**Číslo: DCA/750XL/8**

**DCA/750XL/8      Fuselage Roof, Station 180.85 – Inspection and Repair**

PACSB / XL / 019

### INSPECTION – Fuselage roof, Station 180.85

Figure 1

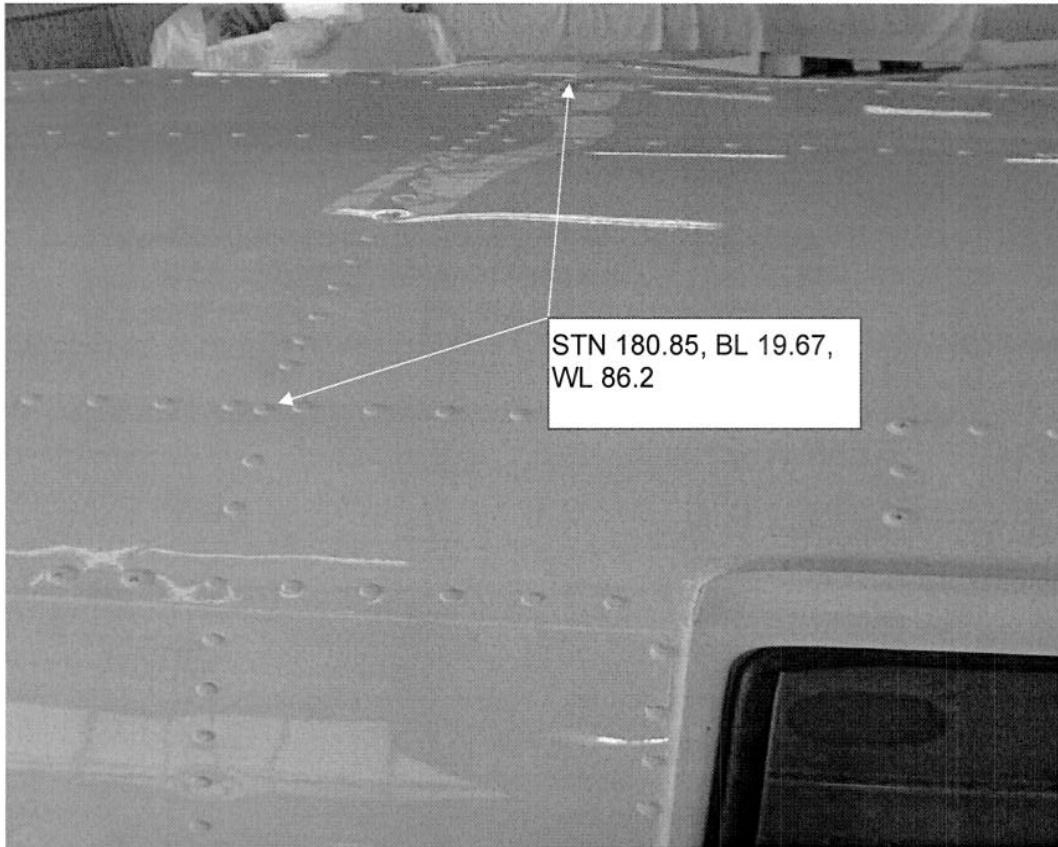
During routine inspection of an aircraft during release to service at Pacific Aerospace Corporation, it was identified that a row of 1/8" solid rivets had been incorrectly fitted where 5/32" solid rivets had been specified in the fuselage top (43 locations). STN 180.85, BL 19.67, WL 86.2 (Fig 1)

A visual inspection of these specific co-ordinates must be performed in order to identify that 5/32" rivets have been fitted and not 1/8".

- 2.1 At the co-ordinates specified visually inspect to determine that the correct rivet 5/32" has been installed. Using aids as necessary, (e.g. verniers) examine the rivet heads in the positions indicated. Refer to the illustration (Fig 1) which shows the fuselage roof.
- 2.2 The rivet heads at the points arrowed should be those of 5/32" rivets, clearly larger than those (1/8"). As a guide the head of the 5/32" rivet should measure  $\varnothing$  0.327" the incorrect 1/8" rivet head size should measure  $\varnothing$  0.289".
- 2.3 If rivets are 5/32", no further work is required complete section 4.0 of this SB.
- 2.4 If the rivets appear to be 1/8", proceed as in part 3.0.

- 3.1 Incorrect rivets to be removed and replaced using the following rivet type MS20470AD5 (43). Components are available from Pacific Aerospace Customer Service.
  - Referring to the Maintenance Manual, Chapters 25 & 53 remove the Roof cabin linings.
  - Drill the heads and remove the 1/8" rivets one at a time, following normal rivet removal procedure.
  - As each rivet is removed, drill the hole out to 5/32", then ream using a number 21 (0.159") ream.
  - Install and drive an MS20470AD5 rivet.
  - Proceed until all 43 affected rivets have been replaced.
  - Paint in accordance with standard aircraft practices refer to Maintenance Manual Chapter 20.
- 3.2 Reinstall the cabin lining referring to the Maintenance Manual, Chapter 25.
